METROPOLITAN GOVERNMENT OF NASHVILLE AND DAVIDSON COUNTY

STAFF RECOMMENDATION
1511 Lillian Street
November 19, 2014

Application: New construction-infill
District: Lockeland Springs-East End Neighborhood Conservation Zoning Overlay
Council District: 06
Map and Parcel Number: 8313043500
Applicant: Mona Hodge, Owner
Project Lead: Sean Alexander, sean.alexander@nashville.gov

Description of Project: The applicant is proposing to construct a new one and one-half story house on a vacant lot.

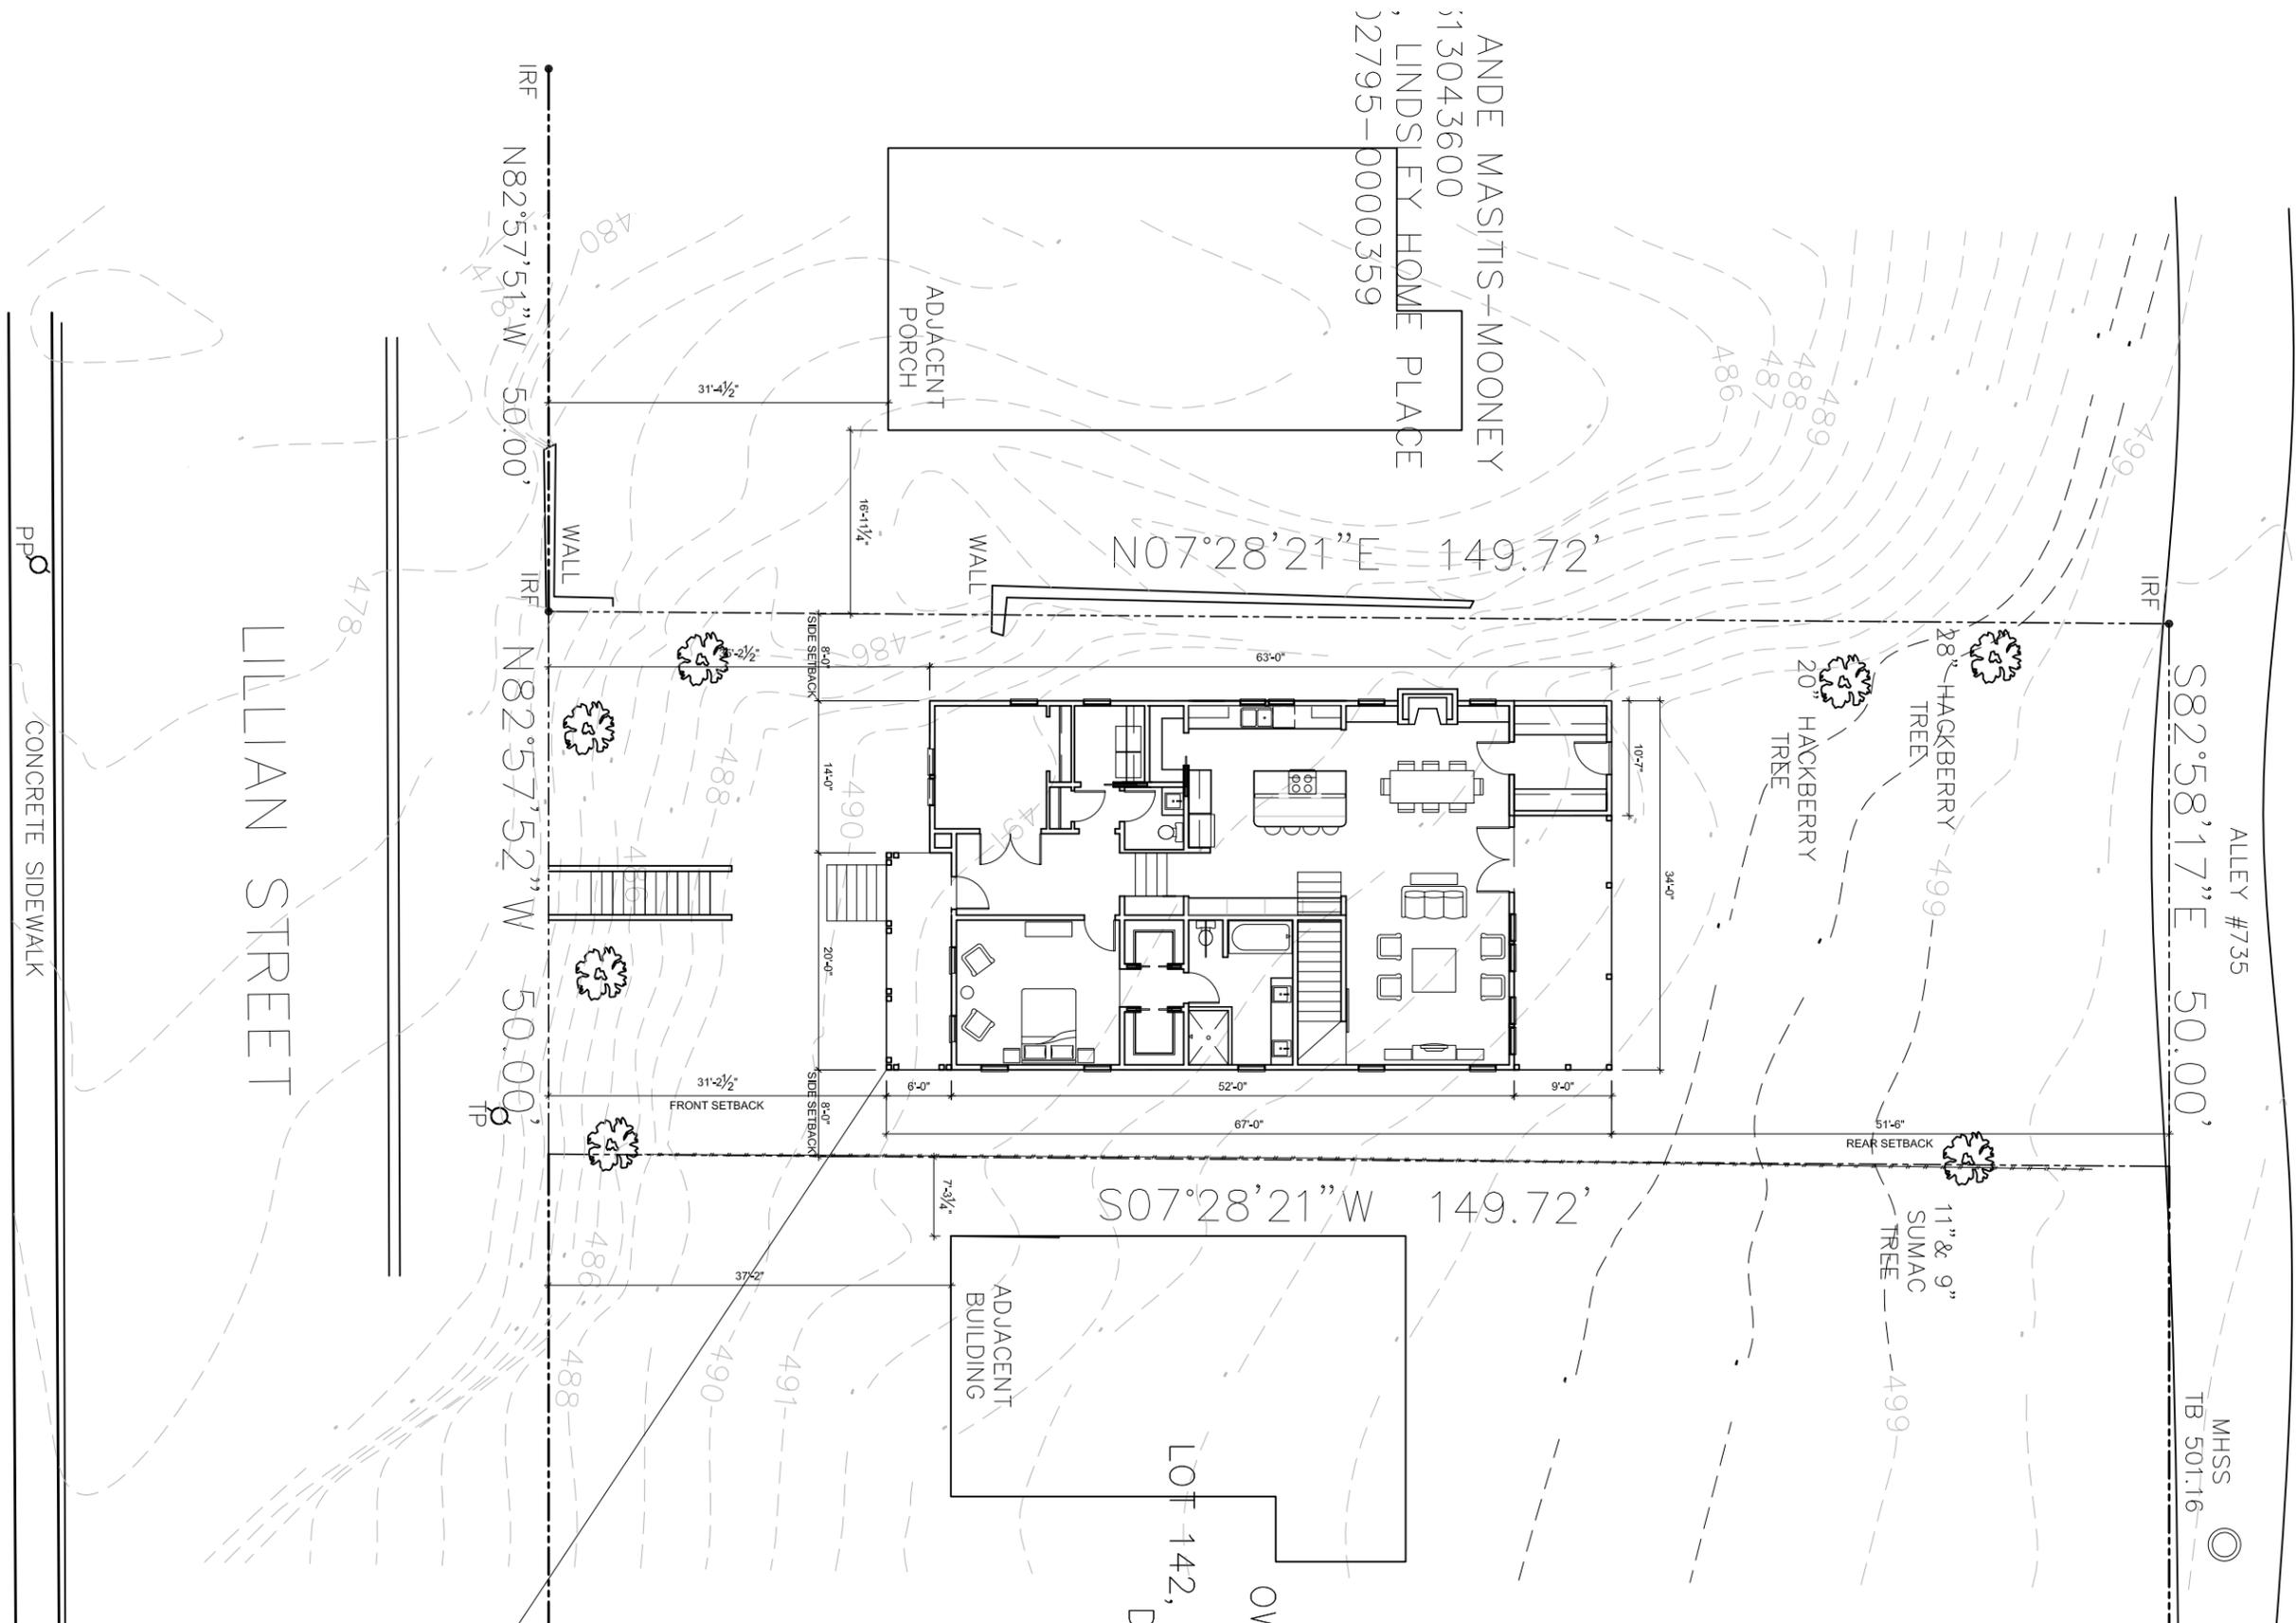
Proportion and Rhythm of Openings: The windows on the proposed infill are all generally twice as tall as they are wide, thereby meeting the historic proportions of openings. There are no large expanses of wall space without a window or door opening. Staff finds the project's proportion and rhythm of openings to meet Section II.B.7.

SITE PLAN

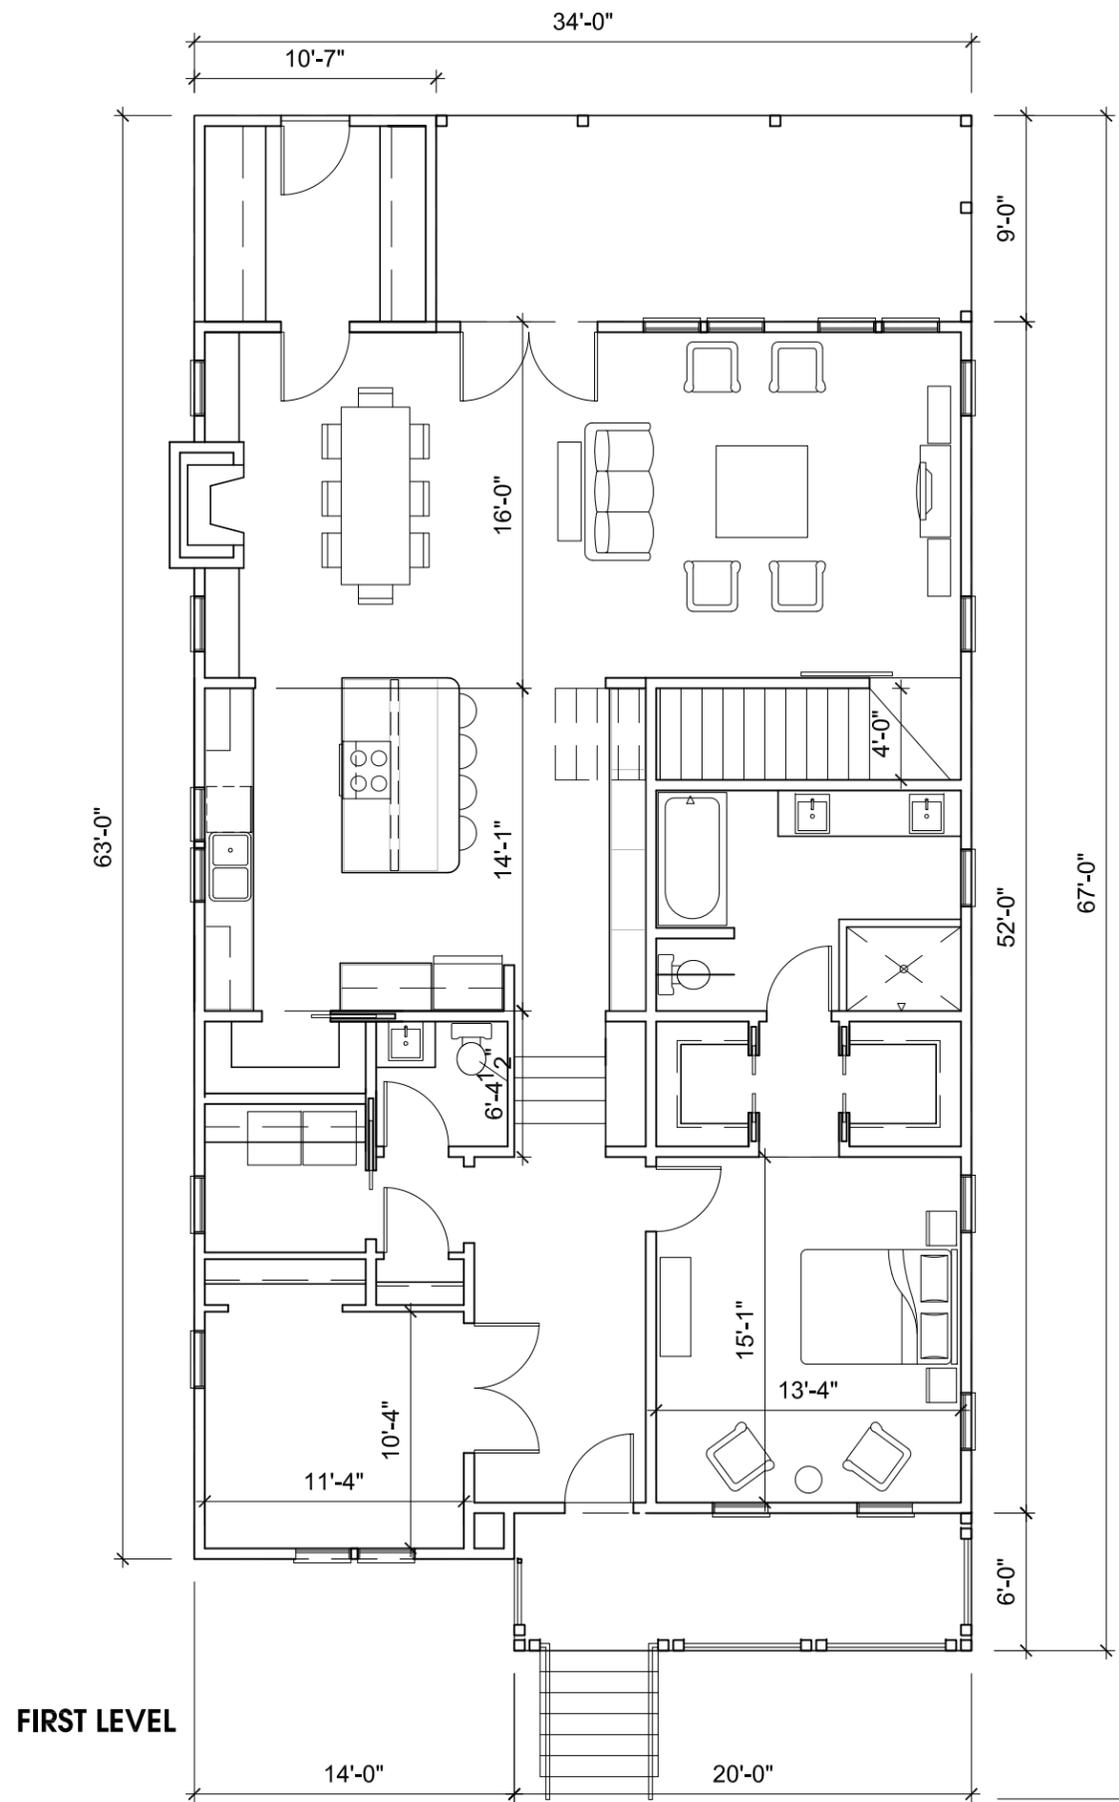
Setback & Rhythm of Spacing: The front setback of the new building will be thirty-one feet (31'), which is the average of other houses on the block. The side setbacks will both be eight feet (8'). These setbacks are in keeping with the setbacks of surrounding houses, and will maintain the established rhythm of spacing on the street. The project meets section II.B.3.

Appurtenances & Utilities: The location of the HVAC and other utilities was not noted. Staff asks that the HVAC be located on the rear façade, or on a side façade beyond the midpoint of the house. The project meets section II.B.9.

FRONT ELEVATION

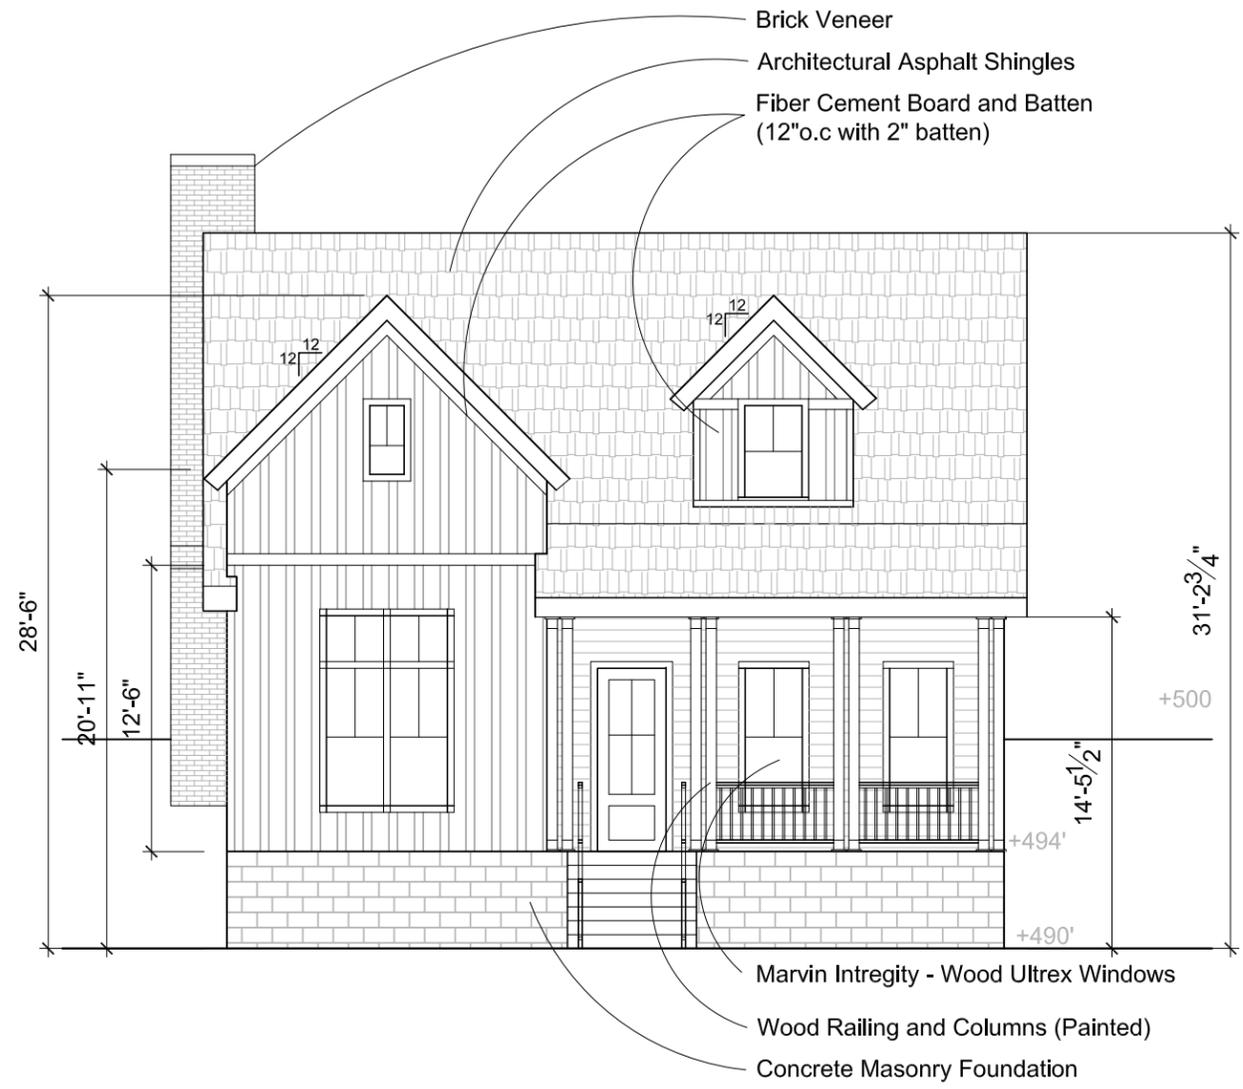
The house will have a leading eave height of eleven feet (11') above the finished floor level, and a front-projecting gabled component with a roof height of twenty-four feet, six inches (24'-6") above floor level. These heights are compatible with surrounding historic structures.

The house will have an asymmetrical front façade with a fourteen foot (14') projecting component and a twenty foot (20') wide partially-recessed front porch. The thirty-four foot (34') total width is greater than the typical historic house on this block, which range from twenty-six feet (26') to thirty-two feet (32'). Several of the houses on this block, however, are non-contributing. On the next block there are several historic houses that are thirty-six feet (36') wide or more. Given that there is not strong historic context on the 1500 block of Lillian, and that the proposal is compatible with the scale of historic houses nearby, staff finds the proposal to meet sections II.B.1 and II.B.2 of the design guidelines.

Roof form: The primary roof of the new building will be a side gable with a pitch of 10:12. From the primary roof ridge, a rear-facing gable will extend toward the rear, with a 6:12 pitch and eaves at sixteen feet (16') above grade at the rear. The front-projecting gable and front dormers will have a pitch of 12:12 and the front porch will have a shed roof with a pitch of 4:12.

- The height of the finished floor level be consistent with adjacent houses; and
- Staff shall approve the foundation material, front porch floor, step and walkway material, porch column trim, brick color, roof color, and the final selection of the windows and doors.
- Staff shall approve the location of the HVAC unit.
- Final drawings showing all corrections and revisions are provided to Staff.
